**Substantive response of the Local Highway Authority to a planning consultation received under The Development Management Order.**

Planning Application Number: P/23/0659/2

Application Address: Gynsill Lane and Anstey Lane Glenfield Leicestershire

Outline application for circa 375 dwellings, public amenity space, a reserve site for a 1FE primary school (if required and in lieu of circa 35 dwellings) and associated infrastructure (All Matters Reserved except Access)

The proposed site access roundabout is shown on BSP drawing number GLGL-BSP-ZZ-XX-DR-S-004 Revision P02, an extract from which is provided overleaf:

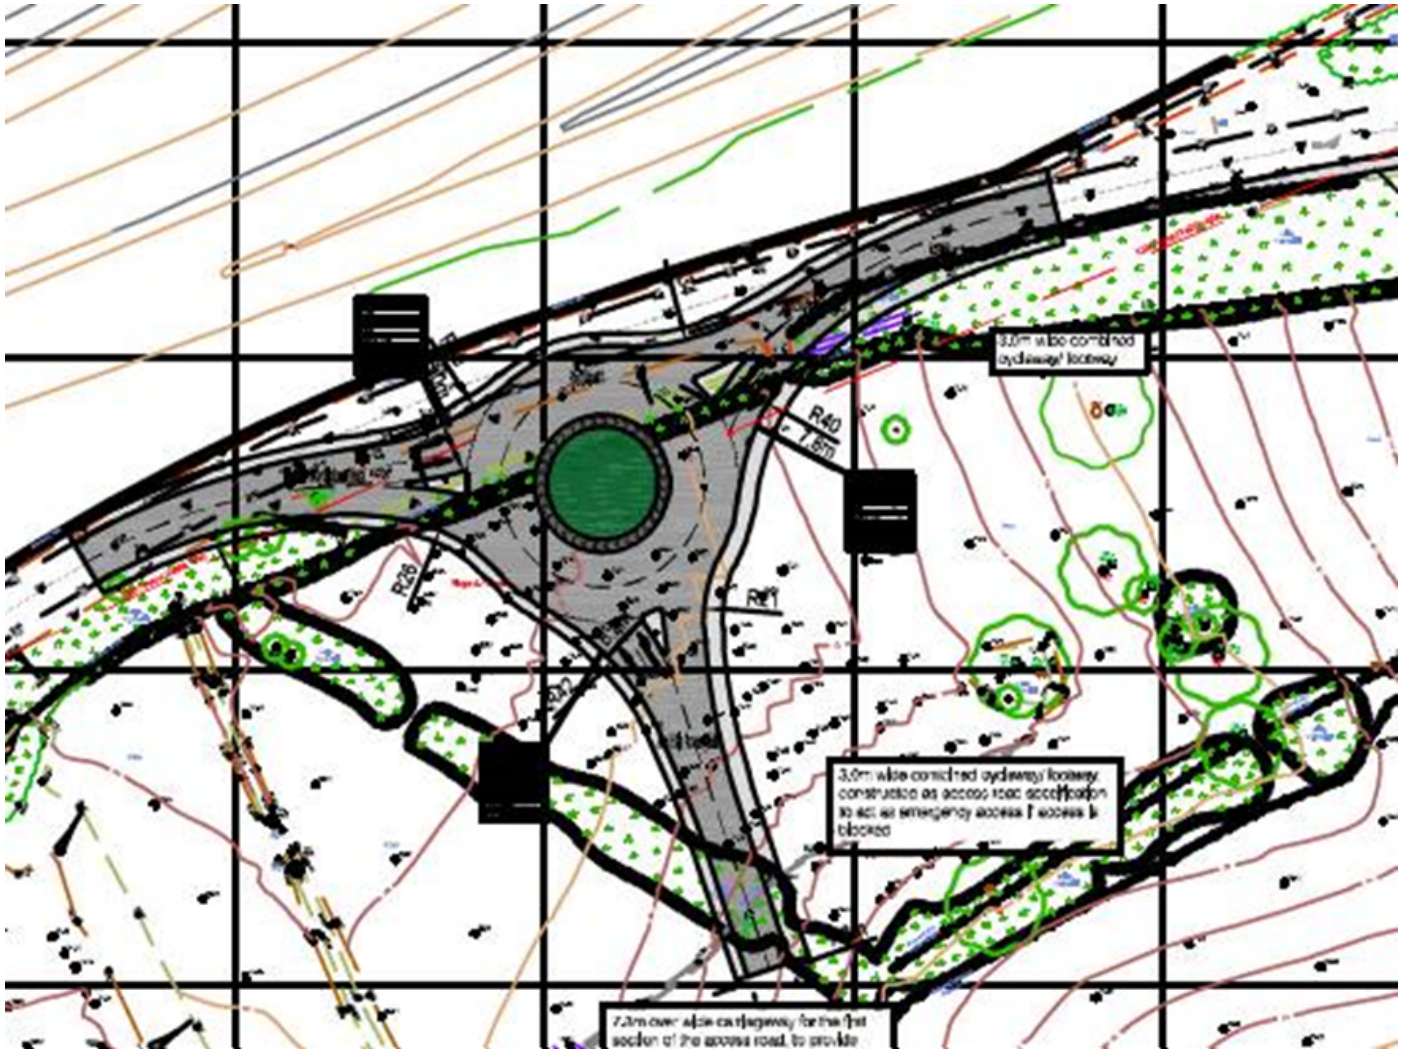
The LHA has significant concerns over the proposed design and location of the roundabout and offers the following comments, which are required to be resolved at this planning stage:

- Details of the design background for this proposal need to be advised by the designer, including choice of junction type and design traffic flows;
- Capacity analysis of the junction has yet to be undertaken and the LHA has concern regarding interaction of queues with the A46 roundabout

- Full geometric design details for the proposed roundabout design need to be clearly shown on the drawing to demonstrate that the junction design would comply with CD116. The drawing indicates design dimensions for entry width, entry radius and exit radius, and the TA advises an ICD of 44m and a 7.3m wide access road. However, no information has been provided for design parameters such as central island diameter / circulatory carriageway width, entry path radius, entry angles, exit width/tapers and exit visibility splays, along with other visibility requirements at the roundabout. These all need to be dimensioned on the drawing for review. From an overview of the proposed layout, the LHA has significant concern that there is insufficient entry deflection and entry path curvature on the Gynsill Lane Eastbound approach.

This raises significant safety concerns given that it could result in vehicle approach speeds being high and could result in PICs, both shunts and failure to give way. It can even be noted that the design provides a straight westbound vehicle path which would enable reckless drivers to bypass the roundabout entirely, on the wrong side of the road, at potentially high speeds;

- Despite the statement in paragraphs 4.5 and 7.6 therefore, the LHA strongly doubts that the design is, '...in line with guidance contained within the DMRB CD116 'Geometric design of roundabouts...';

- It is proposed to relocate the existing 40mph speed restriction so that it commences at the exit from the A46 grade separated junction. This proposal would be acceptable to the LHA, however consideration is required by the Applicant as to whether some form of traffic calming is required should the presence of the roundabout alone be insufficient to reduce vehicles speeds to the new speed limit. The change in speed limit would require a Traffic Regulation Order (TRO) with an associated fee of £7,500 which can be secured by way of S106 contribution. It is important to note that the fee is for processing the TRO only, and all costs associated with signage and any lighting will be entirely at the Applicant's expense;

- Visibility splays of 120m have been shown to the roundabout give way line for each approach on Gynsill Lane. Speed measurements have been undertaken on Gynsill Lane which recorded 85th %ile speeds of 48.2mph Eastbound and 46.0mph Westbound. These would require forward visibility splays of 160m to comply with DMRB CD109 and LHDG Table DG4 requirements. There is concern that for the Eastbound approach, the amended speed restriction would not sufficiently reduce vehicle speeds, and a visibility splay of 160m would still be required on this approach. For the Westbound approach, the proximity of the give-way to the A46 gyratory, and the relocated 40mph speed restriction, should mean that the proposed 120m visibility splay would be sufficient on this approach. However, this needs to be clarified by the Applicant, as the Vehicle Speed Survey' report in Appendix H of the PTA is inconsistent with this;

- The Applicant is requested to show the proposed highway boundary on the drawing. Visibility to the roundabout give-way for westbound traffic approaching from the A46, would require a wide visibility splay to be provided, and the land-take for this would need to be transferred into the highway boundary. This splay would need to be free of any significant obstructions such as existing vegetation. Removal of the existing trees within this visibility splay would require consultation with LCC's forestry team, contactable at [forestry@leics.gov.uk](mailto:forestry@leics.gov.uk);

- Swept path analysis (SPA) has been provided, but this does not currently assess the multi-lane entries on both Gynsill Lane approaches to the junction. These would need to demonstrate sufficient width is provided for each entry lane and on the circulatory carriageway. It is noted that this has been shown for the entry from the proposed access road, but this would also need to be shown for both Gynsill Lane approaches.

- The SPA would need to indicate a 0.5m clearance to proposed kerb-lines and be undertaken for a minimum vehicle speed of 15kph, to demonstrate a realistic path for the wheel track. It is noted that for the right turn manoeuvre from Gynsill Lane Eastbound into the development access, the SPA shows little or no clearance to the central island, and the vehicle path has an abrupt change in direction which is unlikely to represent typical vehicle movements.

- The drawing indicates a 3.0m wide combined footway/cycleway to the South-Eastern side of Gynsill Lane to provide a shared footway/cycleway. This would need to have a width of at least 3.5m overall to include for the absolute minimum horizontal separation required by LTN1/20. The proposed footway width to the North-Western side has not been shown, and the proposals

for this need to be indicated on the drawing. LHDG Table DG9 requires a 2m width for pedestrian only use;

- It is noted that the shared provision continues into the proposed development. However, clarification is required as to what provision is to be made for cyclists to continue West along Gynsill Lane.

- Crossing provision for pedestrians that wish to continue West along Gynsill Lane would need to be provided across the arm for the proposed access road to the development.

- The drawing suggests that approximately 150m West of the A46 gyratory, the shared provision will need to cross Gynsill Lane to connect with the existing segregated cycleway/footway on the North side. The proposed crossing and shared provision would both require tactile paving provision, and this would need to be provided as per DfT Guidance on the Use of Tactile Paving Surfaces. The LHA queries whether the proposed crossing type is the most appropriate and whether any assessments have been undertaken in this regard.

- It is noted that the proposed roundabout layout includes short lengths of reverse curves between the exits and entries to the development arm, to and from the A46. CD116 recommends that these should be avoided between entries and adjacent exits. It is noted that the reverse curve between the development arm entry radius and the Gynsill Lane Westbound exit is the worst location for this issue.

- An existing field access is present off Gynsill Lane approximately 210m East of the A46 Gyratory. It is assumed that this access would be superseded by the new development, but this needs to be clarified and confirmed on the drawing. The LHA would seek its closure via a planning condition.

- It is noted that the drawing has several references to 'Gynsill's Lane' and these need to be corrected to 'Gynsill Lane'.
- It is noted from the TA document that the proposed development is for 345 residential properties plus a primary school. The proposals intend to serve the development from the roundabout. Given that the site is being brought forward in isolation from the city allocation, this is a single access point, which would not comply with the requirements of LHDG 3.15 and Table DG1. Whilst the LHA is able to view such proposals on their merits, such developments should generally require at least two access points to the highway network, and consideration should be given to the provision of a secondary access.

- A Stage 1 Road Safety Audit has not been provided for the proposals, and this would have to be submitted along with a Designer's Response to any problems identified along with an amended design if required.

Notwithstanding the lack of an RSA1, it is the LHA's view that the roundabout would benefit from a complete redesign if road safety concerns are to be overcome.
